Application Number	
Filing Date	02-Oct-2014
First Named Inventor	Peter John COUSINS
Title	FRONT CONTACT SOLAR CELL WITH FORMED EMITTER
Art Unit	
Examiner Name	
Attorney Docket Number	10031.004211

In the embodiment of claim 1, the emitter is disposed over the tunnel dielectric and forms a backside junction with the substrate. It is respectfully submitted that this feature of claim 1 is not taught or suggested by the combination of Meier, Okayasu, Ohmi, and Foglietti.

FIG. 3D

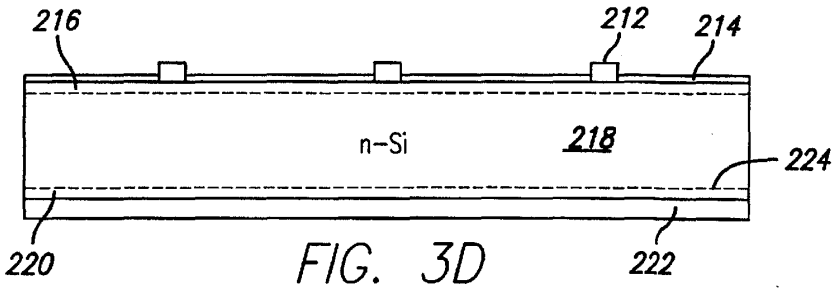
The final office action suggests that in the cited combination, Meier discloses the recited backside junction. Meier FIG. 3D is reproduced below for ease of discussion.

Meier discloses a solar cell with an aluminum alloy back junction (Meier, Title). More specifically, Meier discloses forming a p+ layer 220 ("emitter") that forms a backside junction with the n-Si base layer 218 ("substrate") within the base layer 218 by doping using the aluminum contact layer 222 (Meier, col. 6, lines 51-54). That is, the main

FIG. 3D

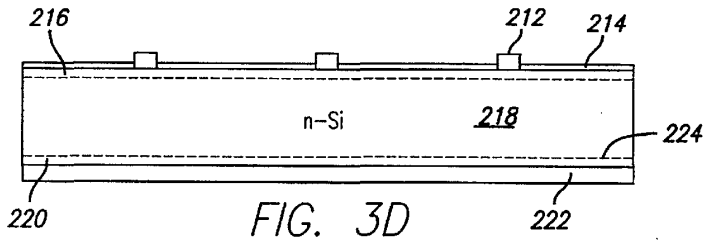
The final office action suggests that in the cited combination, Meier discloses the recited backside junction. Meier FIG. 3D is reproduced below for ease of discussion.

Meier discloses a solar cell with an aluminum alloy back junction (Meier, Title). More specifically, Meier discloses forming a p+ layer 220 ("emitter") that forms a backside junction with the n-Si base layer 218 ("substrate") within the base layer 218 by doping using the aluminum contact layer 222 (Meier, col. 6, lines 51-54). That is, the primary teaching of Meier is to form an aluminum alloy back junction by forming the p+ layer 220 within the substrate by diffusion into the substrate using the aluminum alloy electrode, thereby providing a strongly doped p-type emitter (Meier, abstract).

FIG. 3D

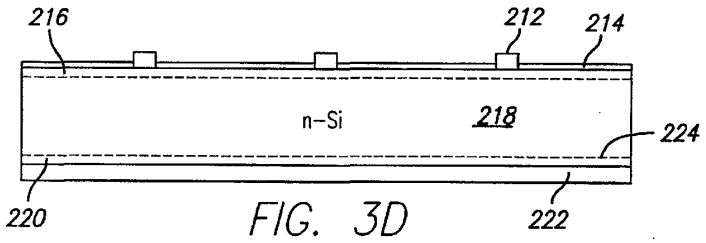
The final office action suggests that in the cited combination, Meier discloses the recited backside junction. Meier FIG. 3D is reproduced below for ease of discussion.

Meier discloses a solar cell with an aluminum alloy back junction (Meier, Title). More specifically, Meier discloses forming a p+ layer 220 that forms a backside junction with the n-Si base layer 218, within the base layer 218, by doping using the aluminum contact layer 222 (Meier, col. 6, lines 51-54). That is, the primary teaching of Meier is to form an aluminum alloy back junction by forming the p+ layer 220 by diffusion into the

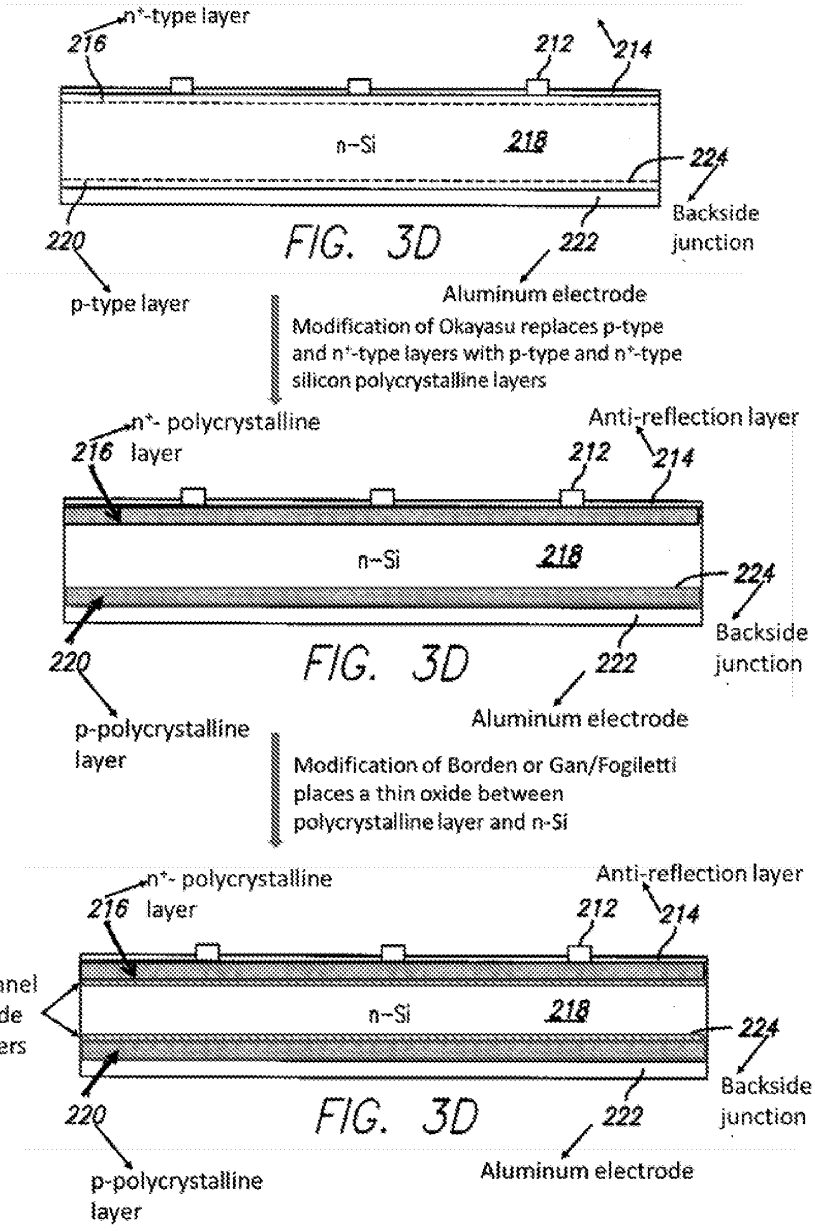
Appellant argues with respect to claim 1 that while Meier discloses a backside junction formed between the emitter (220) and base (228) Meier does not disclose the tunnel oxide between the base and emitter. Furthermore, if there were a tunnel oxide present in Meier the formation of the emitter would not be possible since it is formed from diffusion with the contact layer (222).

Appellant further argues that Okayasu discloses a BSF solar cell and that a BSF layer cannot form a backside junction with the substrate and therefore the combination of Meier and Okayasu is not possible.

FIG. 3D

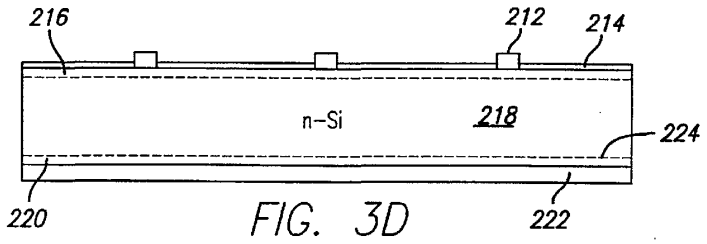
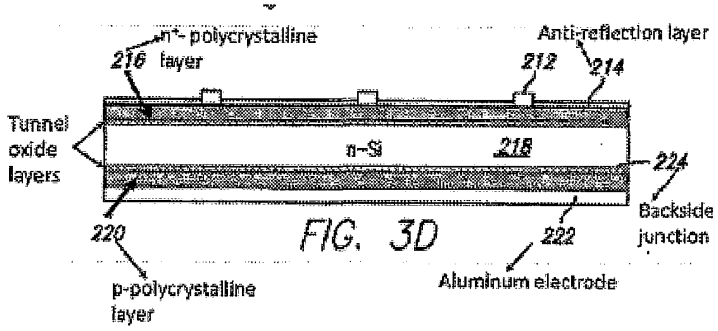
The drawing on page 10 of the Examiner's Answer shows the extent of the proposed modification to Meier. Comparing Meir's original structure,

to the modified structure,

one can see immediate major differences.

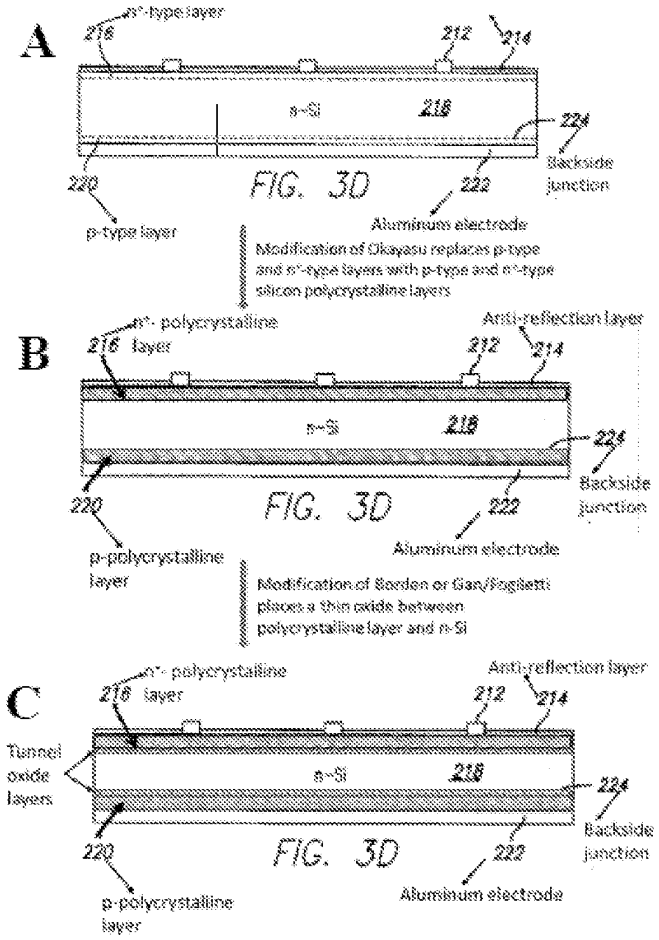
With respect to claim 1, the Examiner finds that Meier teaches the majority of the limitations. Final Act. 3. The Examiner finds that Meier teaches a method of forming a junction consisting of a p-type emitter on an n-type substrate which comprises using an aluminum electrode as a p-type dopant material and driving the dopant in through annealing. Ans. 11 (citing Meier col. 6, ll. 35–50). The Examiner further finds that Meier discloses the presence of a front surface field formed through thermal diffusion and comprised of the same type of dopant as the n-type substrate. *Id.* (citing Meier col. 5, ll. 43–49).

The Examiner finds that Okayasu discloses an alternative method for forming a doped emitter or a surface field on a dope substrate. *Id.* The Examiner finds that Okayasu teaches depositing a doped polysilicon emitter and dope surface field on a doped single crystalline substrate. *Id.* (citing Okayasu ¶¶ 14, 43). The Examiner finds that Okayasu teaches that its method of depositing doped polysilicon layers is preferable to that of thermal diffusion (as taught in Meier) because it can be performed at lower temperatures, preventing damage to the substrate, and allows more accurate control of the emitter thickness. *Id.* (citing Okayasu ¶ 8).

The Examiner concludes that one of ordinary skill in the art at the time of the invention would have found it obvious to employ Okayasu's method of forming an emitter or surface field in Meier's back junction solar cell for the advantages articulated by Okayasu. *Id.* at 12.
